SECTION 4.55 APPLICATION
33 UPPER CLIFFORD AVENUE
LOT C DP 102834 FAIRLIGHT
DA166/2015

S4.55 APPLICATION DRAWING LIST

DEVELOPMENT CONSENT DA-166/2015
NORTHERN BEACHES COUNCIL
DEVELOPMENT MODIFICATION MOD2018/0715
BASIX CERTIFICATE No A336197_03

S4.55 APPLICATION
ADDITIONS & ALTERATIONS
33 UPPER CLIFFORD AVENUE
FAIRLIGHT

Drawing title
ROOF PLAN

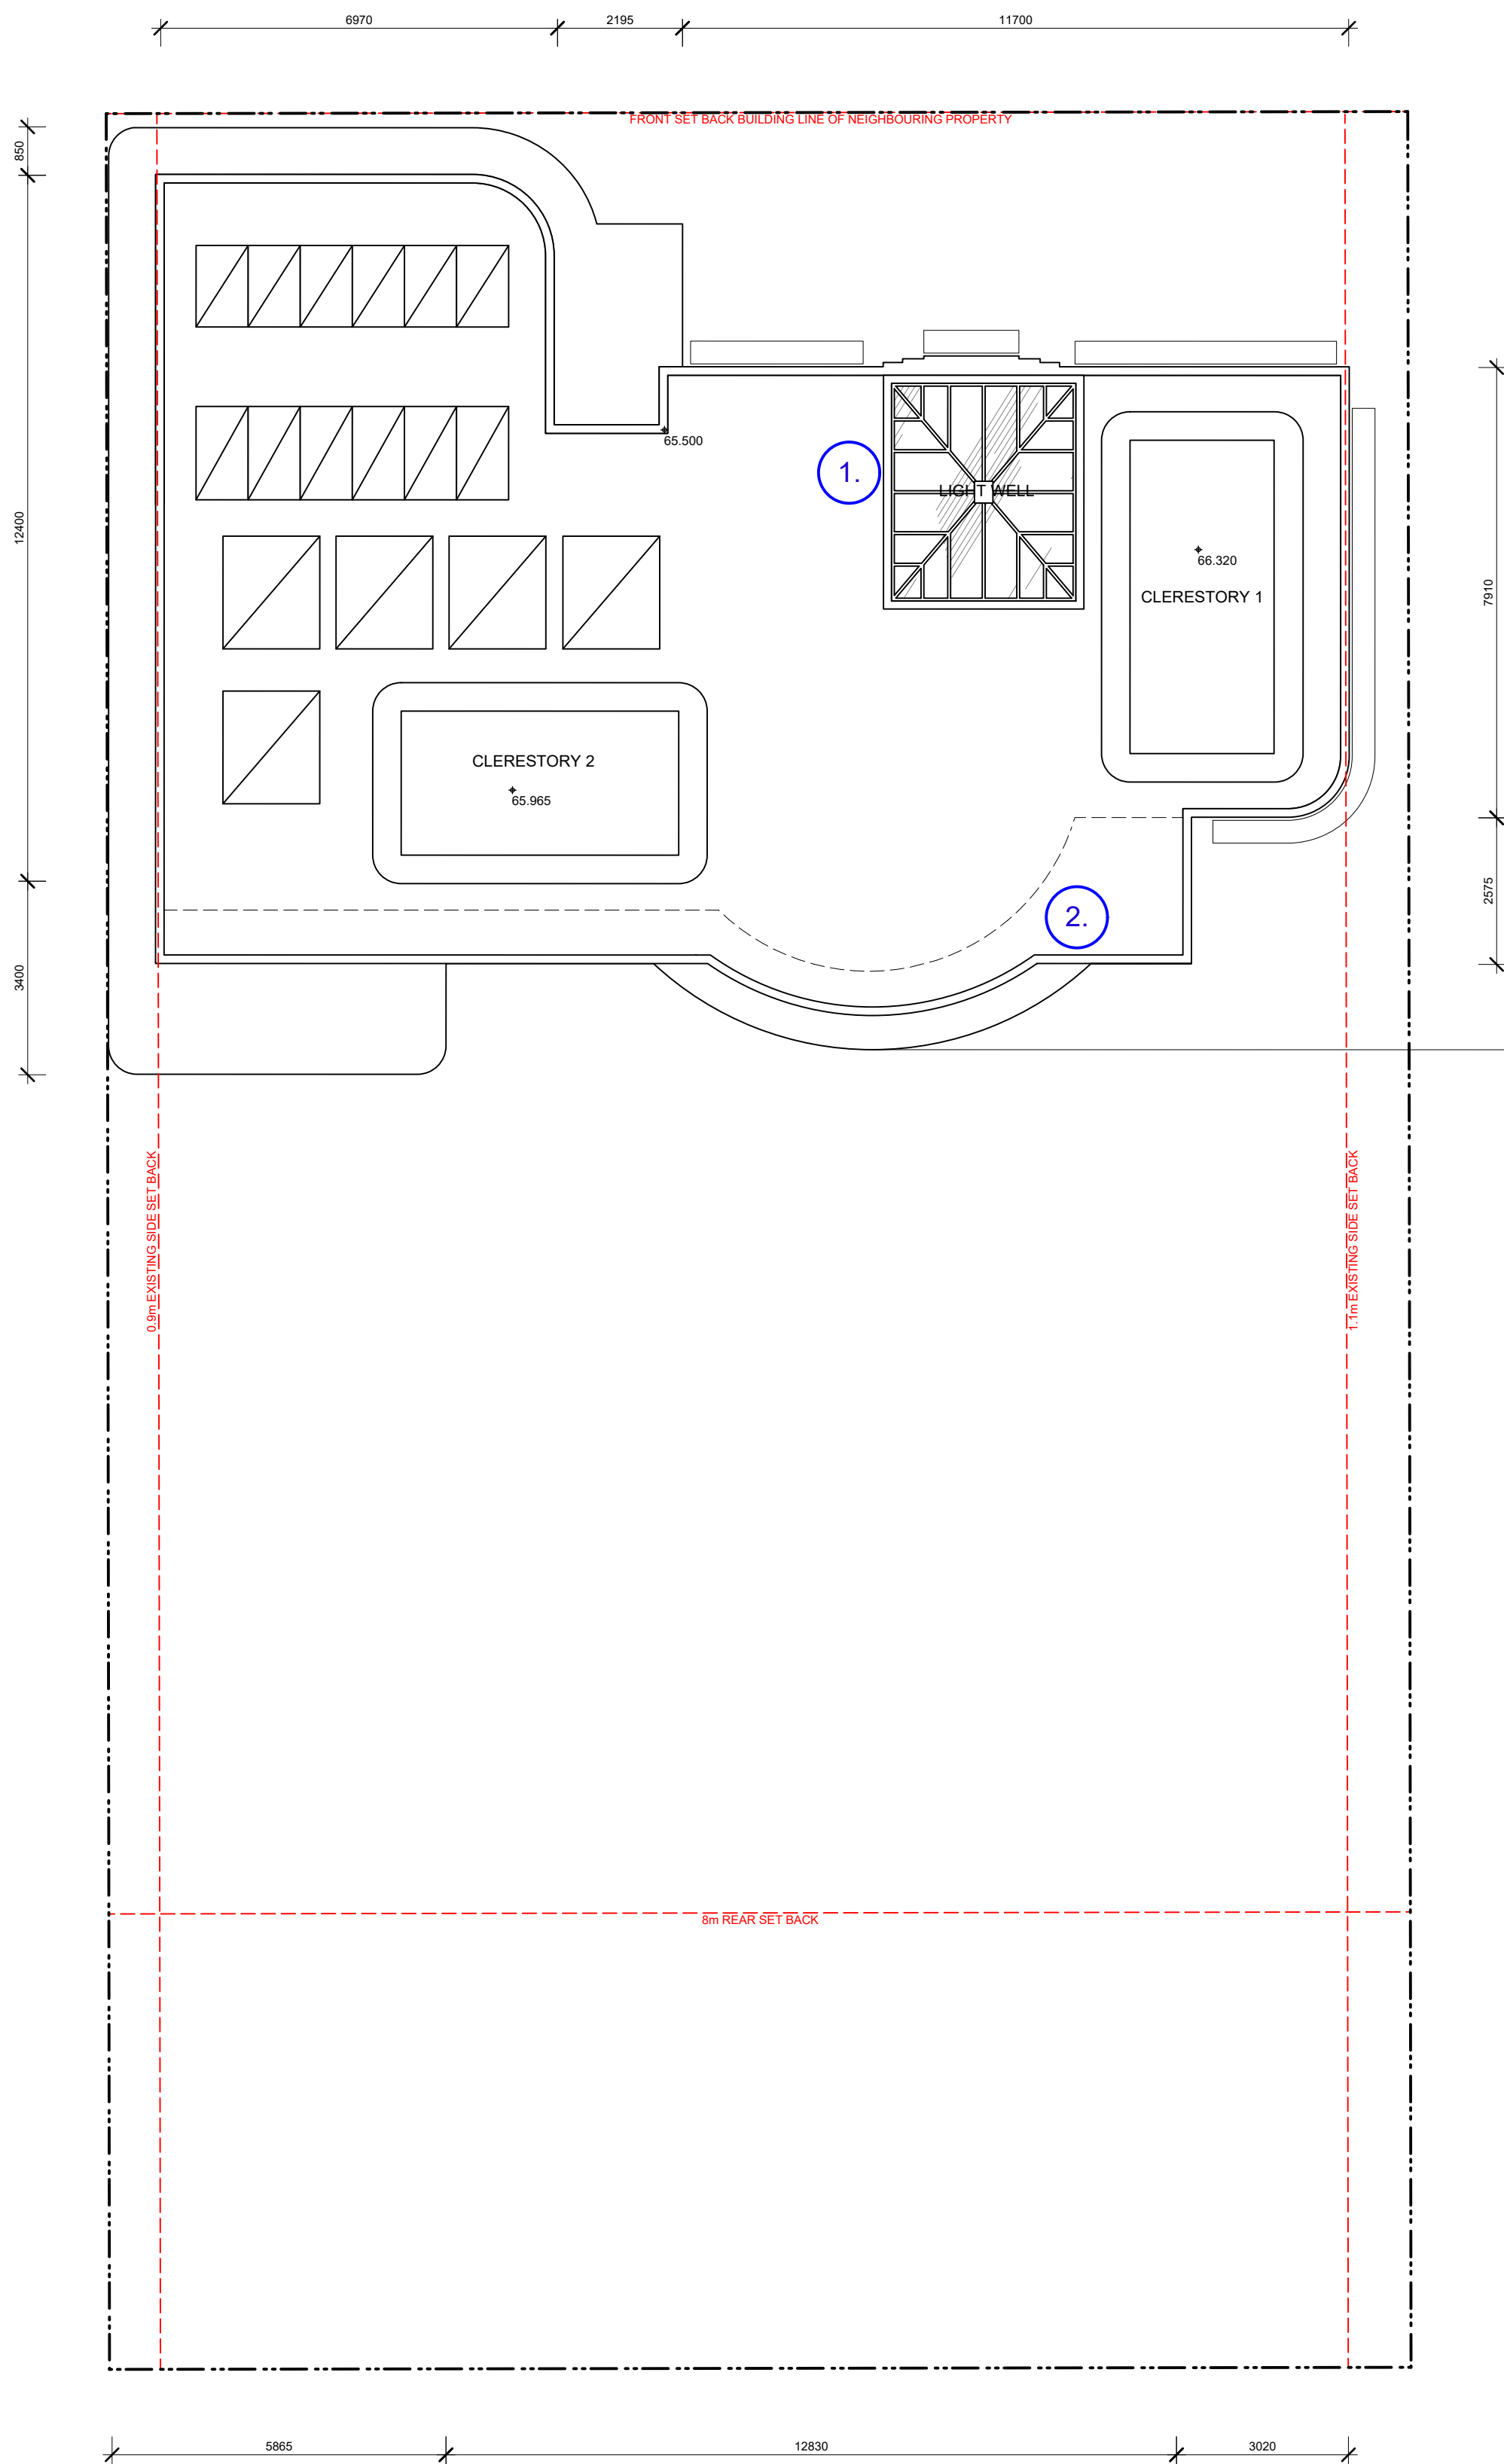
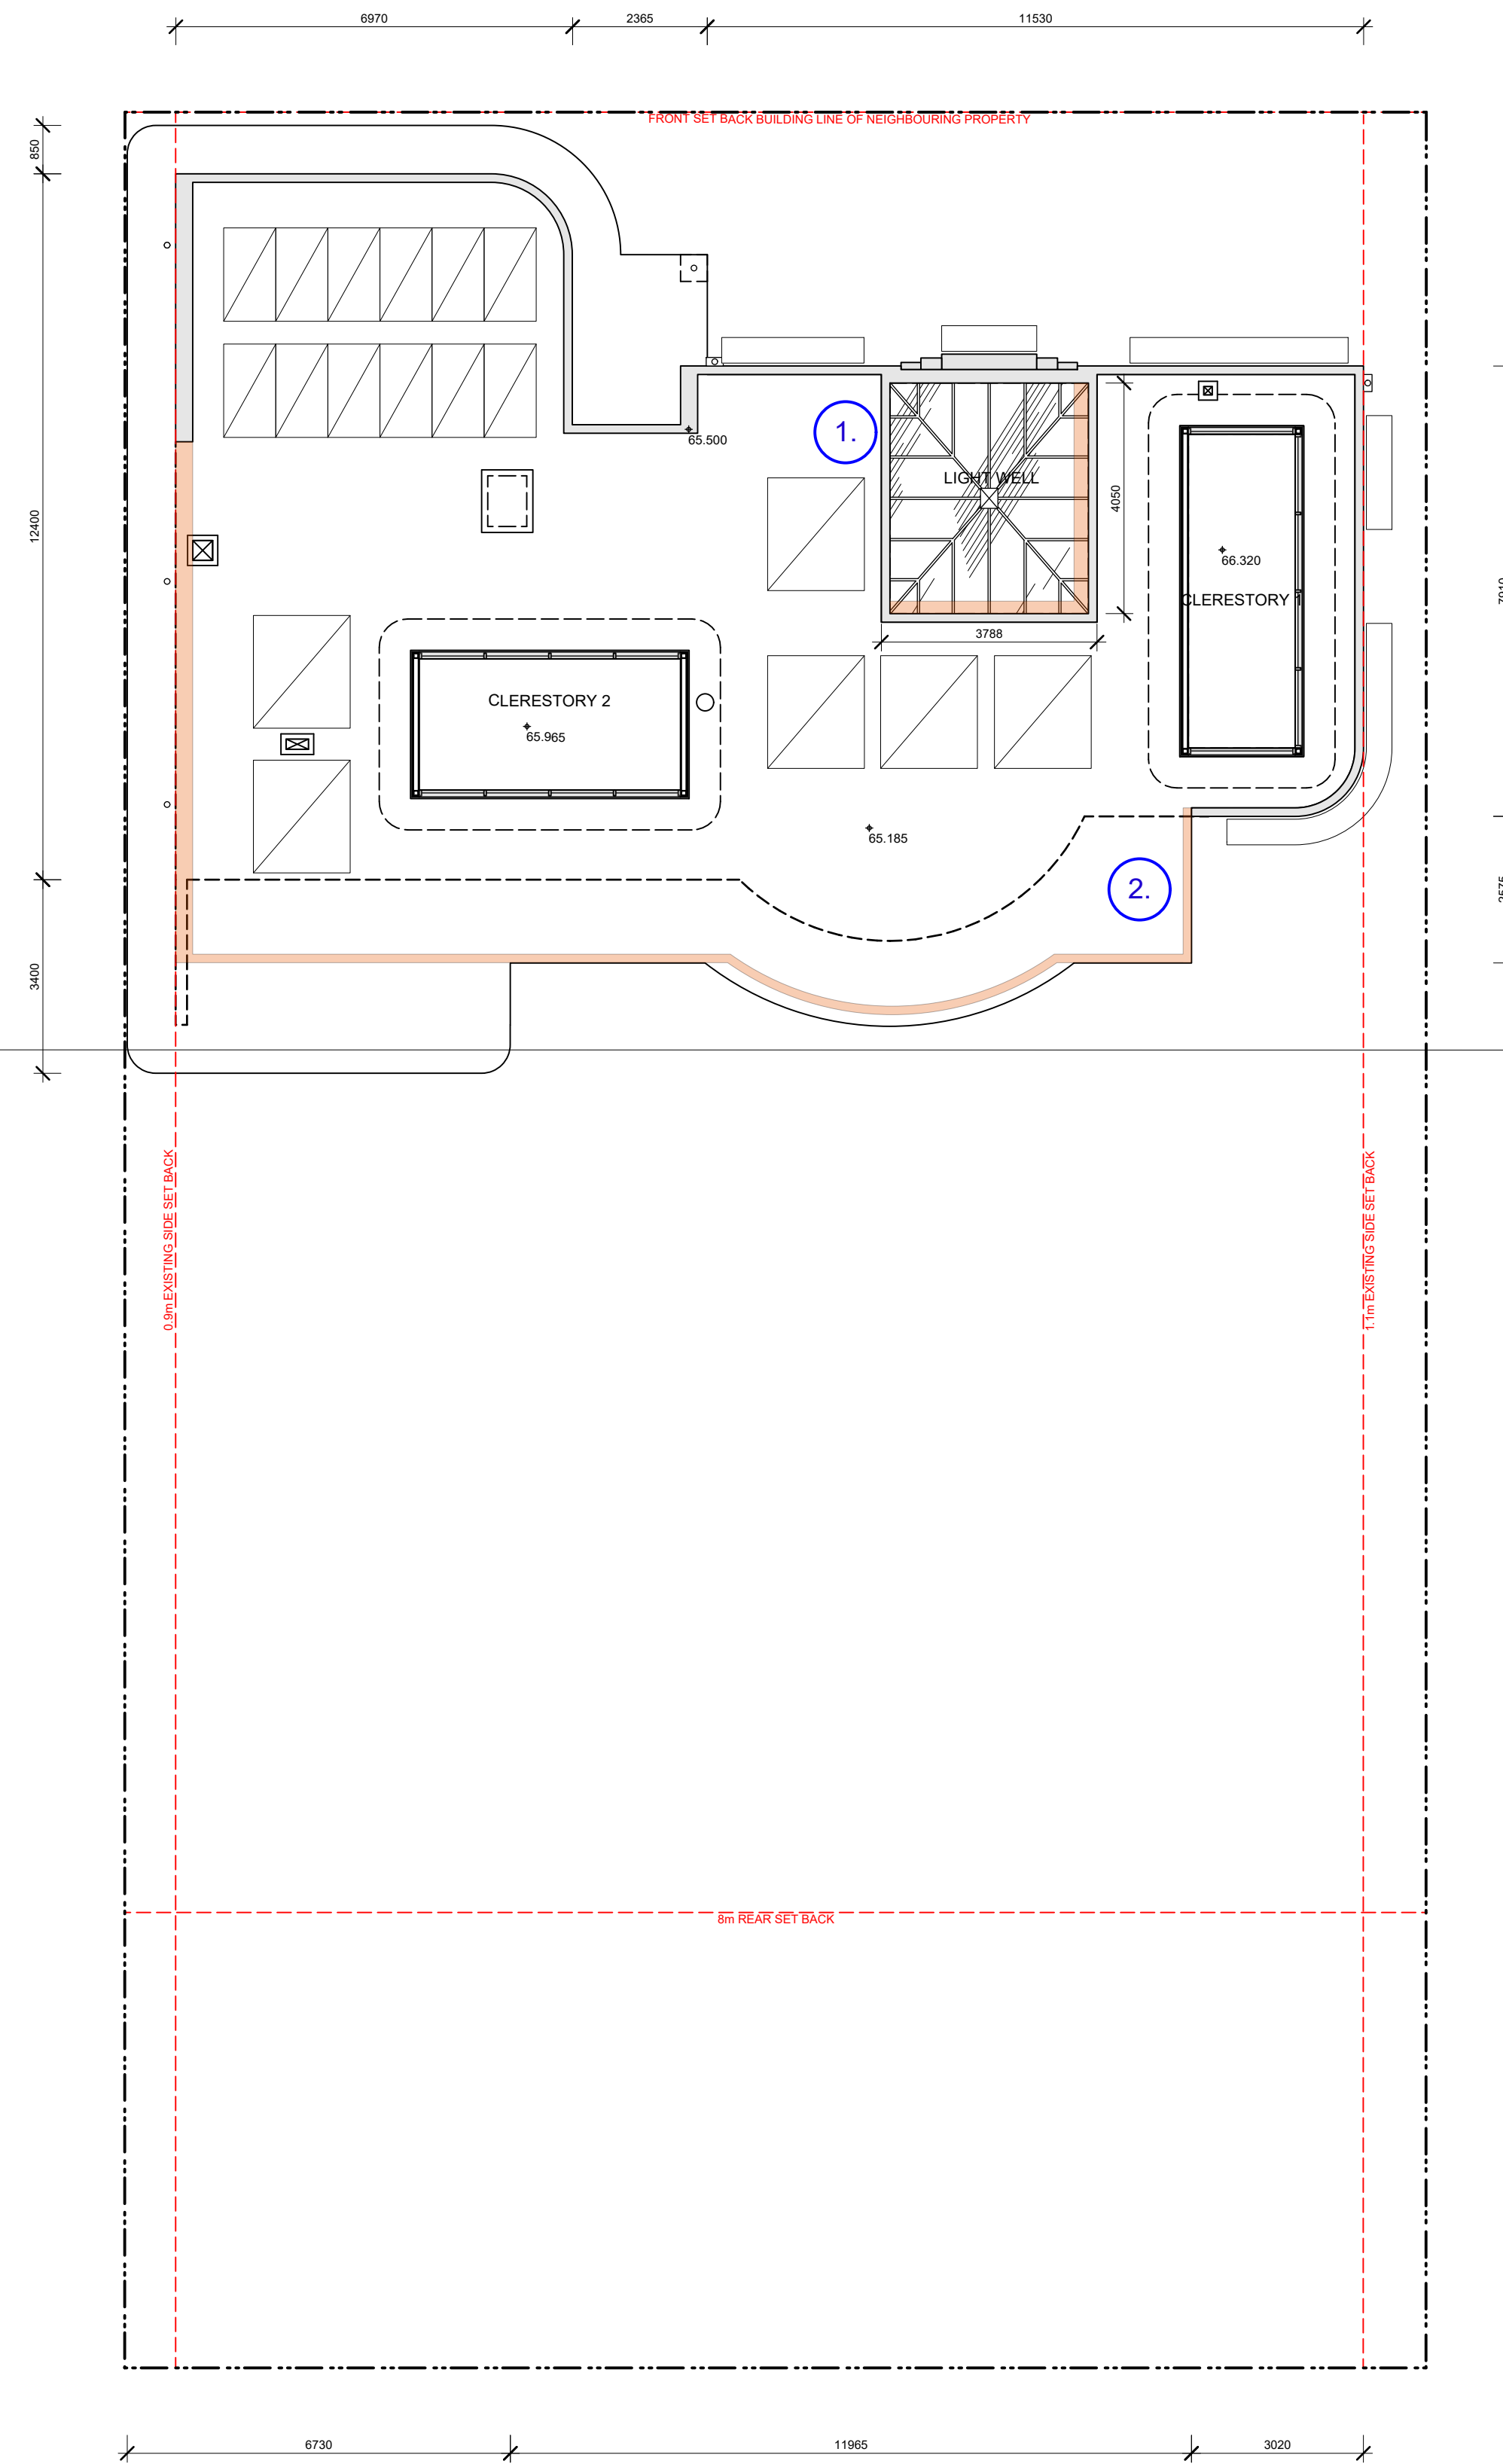
- ROOF
1. MINOR CHANGE TO ROOF LIGHT OVER STAIR WELL
 2. UPDATE ROOF DESIGN TO COMPLY WITH PREVIOUS S4.55 CONDITIONS - REMOVE PART OF PARAPET
